FIELD INSPECTION REPORT

NE STACK C, NE LEG C & SOUTH TRUSS LEVELS 2-6

SEPTEMBER 1, 2021

ERI PROJECT 38470/38471
977 FT SELF-SUPPORT TOWER
SAN FRANCISCO, CA
ASRN 1001289

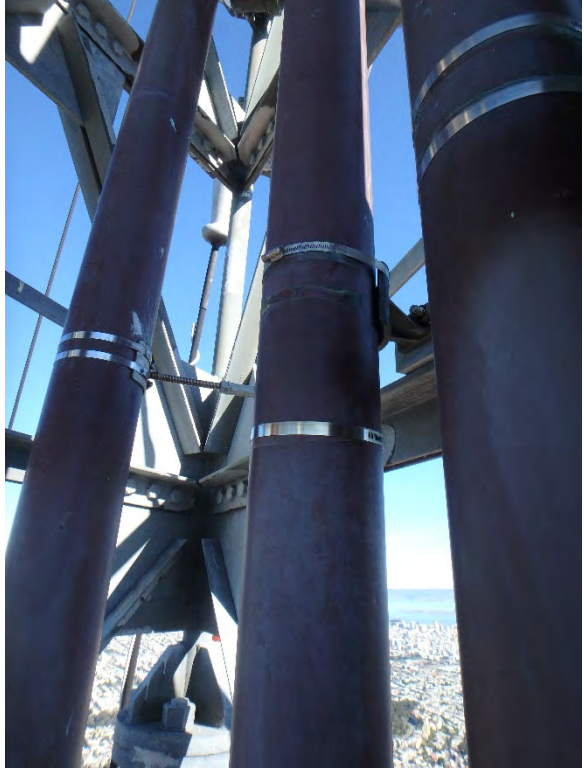
OBSERVATION 1:	LOCATION:
	NE Stack C, Level 6.38
	CONCERN:
	Loose hose clamps on 6-1/8" rigid line fixed hanger
	RECOMMENDED ACTION:
Secure loose hose clamps	ADDITIONAL COMMENTS:
N/A	
OBSERVATION 2:	LOCATION:
	NE Stack C, Level 6.32
	CONCERN:
	Moderate rust on side-mount bracket assembly
	RECOMMENDED ACTION:
Surface prepare and treat IAW STI-SOP-0001	ADDITIONAL COMMENTS:
N/A

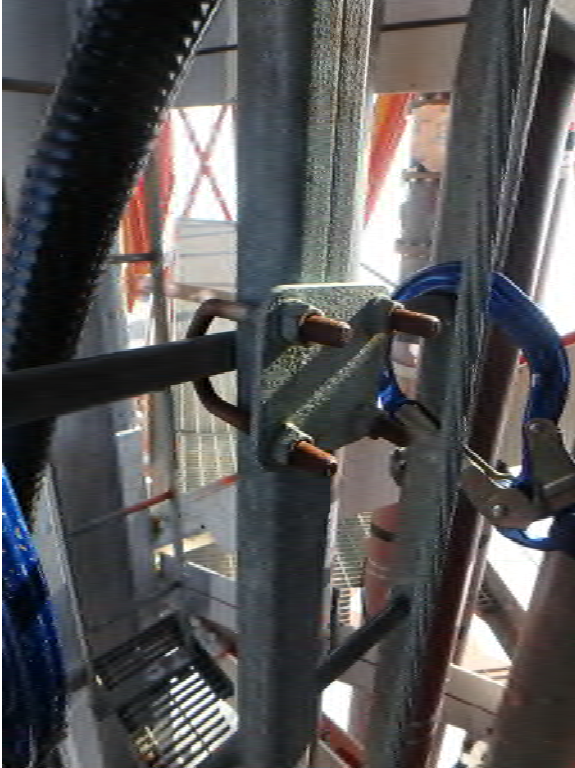
Moderate rust on safety climb top anchorage v-bolts

Replace v-bolts (x3)

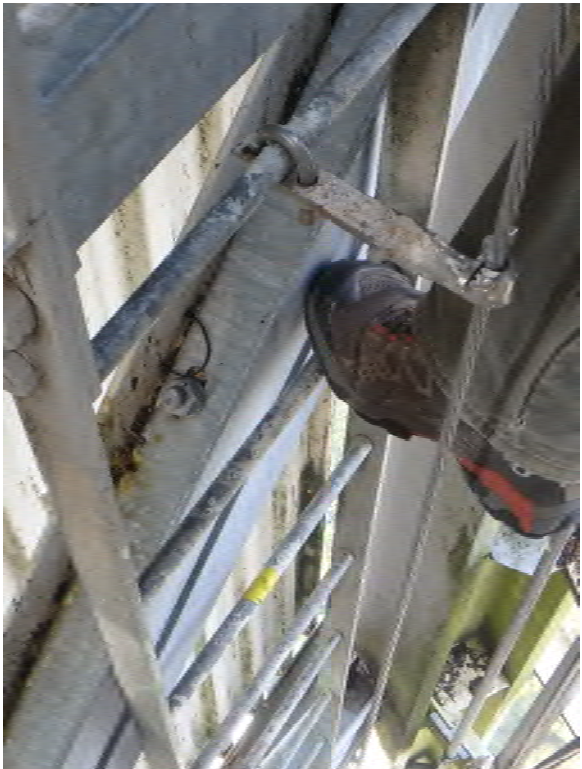
<p>OBSERVATION 15:</p> 	<p>LOCATION: NE Leg C, Level 4.18, X-Face</p> <p>CONCERN: Bent climbing ladder rungs</p> <p>RECOMMENDED ACTION: Field-straighten bent rung (x2)</p> <p>ADDITIONAL COMMENTS: N/A</p>
<p>OBSERVATION 16:</p> 	<p>LOCATION: NE Leg C, Level 4.12-4.13, Ca</p> <p>CONCERN: Moderate/severe rust on column bolts</p> <p>RECOMMENDED ACTION: Surface prepare bolts and replace if material loss exceeds limits set in the 2014 Bolt Replacement Criteria, Tables 5 & 6. If material loss is within acceptable tolerances, repair and coat IAW STI-SOP-0001.</p> <p>ADDITIONAL COMMENTS: N/A</p>

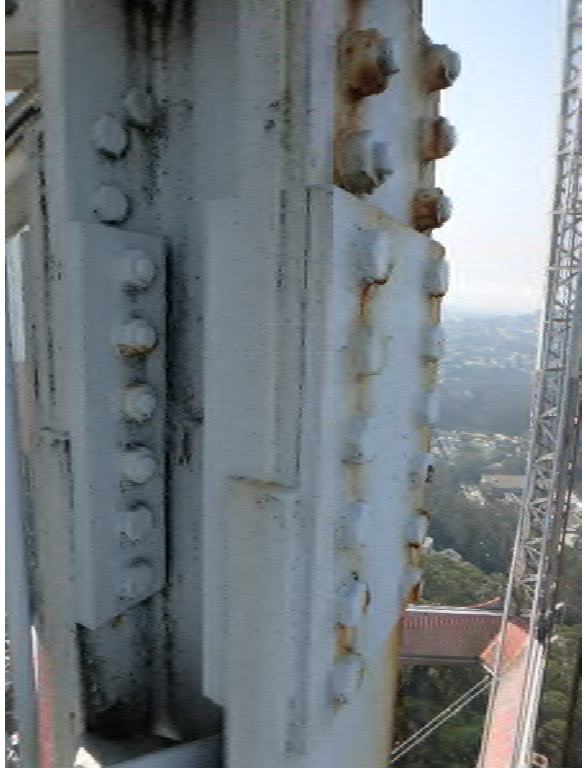
OBSERVATION 19:	LOCATION:
	NE Leg C, Level 3.29-3.30, Ca
	CONCERN:
	Moderate/severe rust on column bolts
	RECOMMENDED ACTION:
	Surface prepare bolts and replace if material loss exceeds limits set in the 2014 Bolt Replacement Criteria, Tables 5 & 6. If material loss is within acceptable tolerances, repair and coat IAW STI-SOP-0001.
	ADDITIONAL COMMENTS:
	N/A
OBSERVATION 20:	LOCATION:
	NE Leg C, Level 3.23-3.24, Ca
	CONCERN:
	Moderate/severe rust on column bolts
	RECOMMENDED ACTION:
	Surface prepare bolts and replace if material loss exceeds limits set in the 2014 Bolt Replacement Criteria, Tables 5 & 6. If material loss is within acceptable tolerances, repair and coat IAW STI-SOP-0001.
	ADDITIONAL COMMENTS:
	N/A

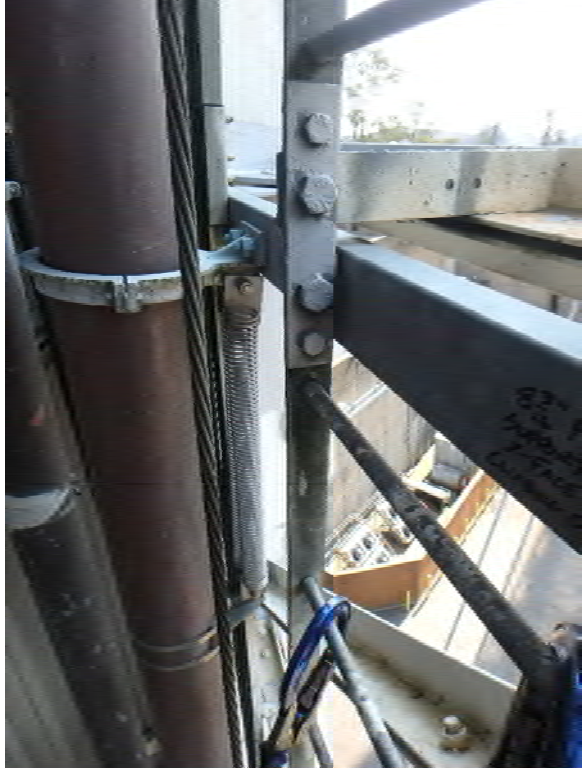
OBSERVATION 23:	LOCATION:
	NE Leg C, Level 3.11-3.12, Ca
	CONCERN:
	Moderate/severe rust on column bolts
	RECOMMENDED ACTION:
	Surface prepare bolts and replace if material loss exceeds limits set in the 2014 Bolt Replacement Criteria, Tables 5 & 6. If material loss is within acceptable tolerances, repair and coat IAW STI-SOP-0001.
ADDITIONAL COMMENTS:	N/A
OBSERVATION 24:	LOCATION:
	NE Leg C, Level 3.5-3.6, Ca
	CONCERN:
	Moderate/severe rust on column bolts
	RECOMMENDED ACTION:
	Surface prepare bolts and replace if material loss exceeds limits set in the 2014 Bolt Replacement Criteria, Tables 5 & 6. If material loss is within acceptable tolerances, repair and coat IAW STI-SOP-0001.
ADDITIONAL COMMENTS:	N/A

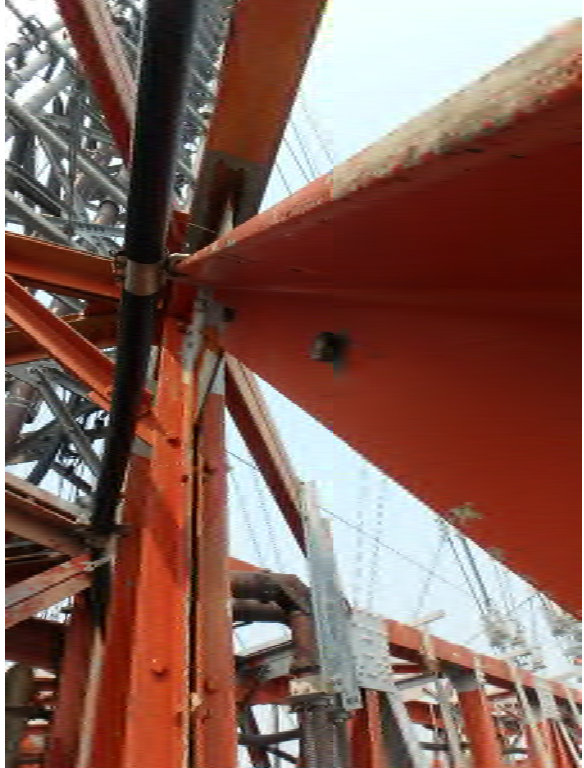
<p>OBSERVATION 35:</p> 	<p>LOCATION: South Truss Level 6, Panel 6.1</p> <p>CONCERN: Damaged top rail (bent and severely rusted at corner)</p> <p>RECOMMENDED ACTION: Replace rail assembly</p> <p>ADDITIONAL COMMENTS: N/A</p>
--	--

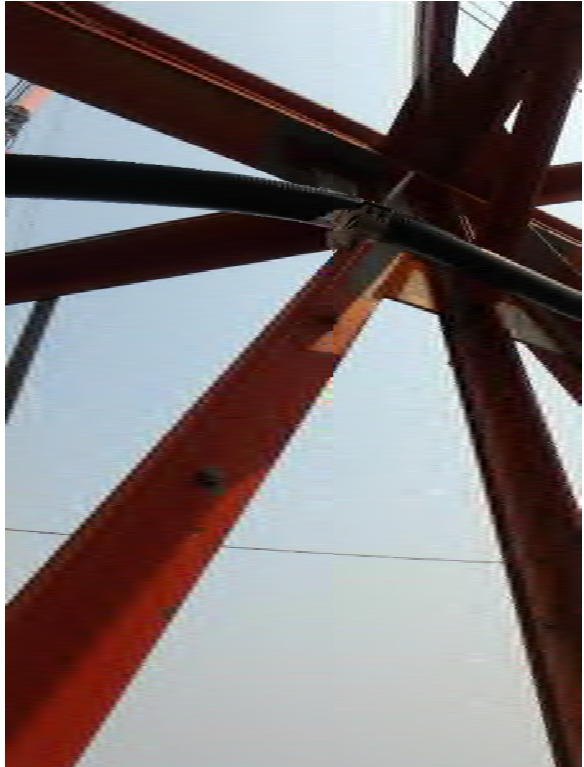
<p>OBSERVATION 36:</p> 	<p>LOCATION: South Truss Level 6, Panel 6.1-6.2</p> <p>CONCERN: Mild rust on HLL shackle bolt</p> <p>RECOMMENDED ACTION: Surface prepare and treat IAW STI-SOP-0001</p> <p>ADDITIONAL COMMENTS: N/A</p>
--	---

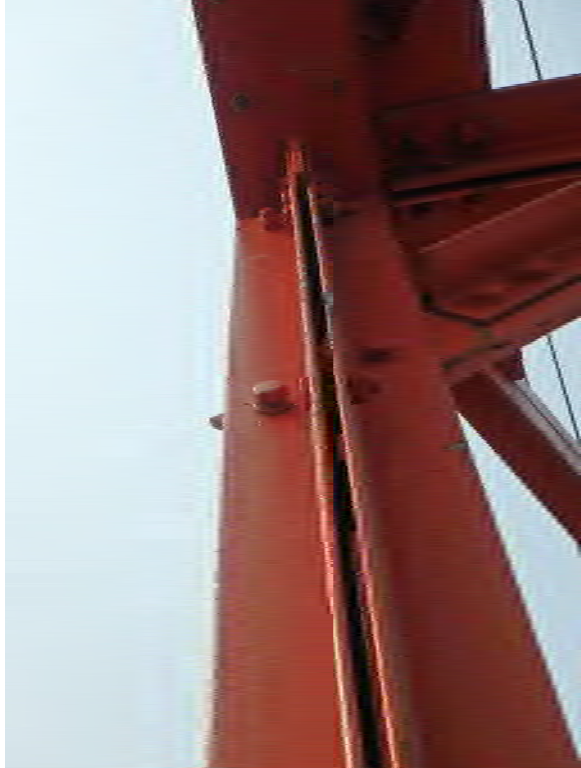
<p>OBSERVATION 37:</p> 	<p>LOCATION: South Truss Level 6, Panel 6.4-6.5</p> <p>CONCERN: Loose stitch bolt (x2); diag</p> <p>RECOMMENDED ACTION: Stitch bolts loosened to facilitate gusset reinforcement which was in progress during inspection; check and ensure stitch bolts are fully retightened</p> <p>ADDITIONAL COMMENTS: N/A</p>
<p>OBSERVATION 38:</p> 	<p>LOCATION: South Truss Level 6, Panel 6.5</p> <p>CONCERN: Loose stitch bolt (x2); vertical</p> <p>RECOMMENDED ACTION: Stitch bolts loosened to facilitate gusset reinforcement which was in progress during inspection; check and ensure stitch bolts are fully retightened</p> <p>ADDITIONAL COMMENTS: N/A</p>
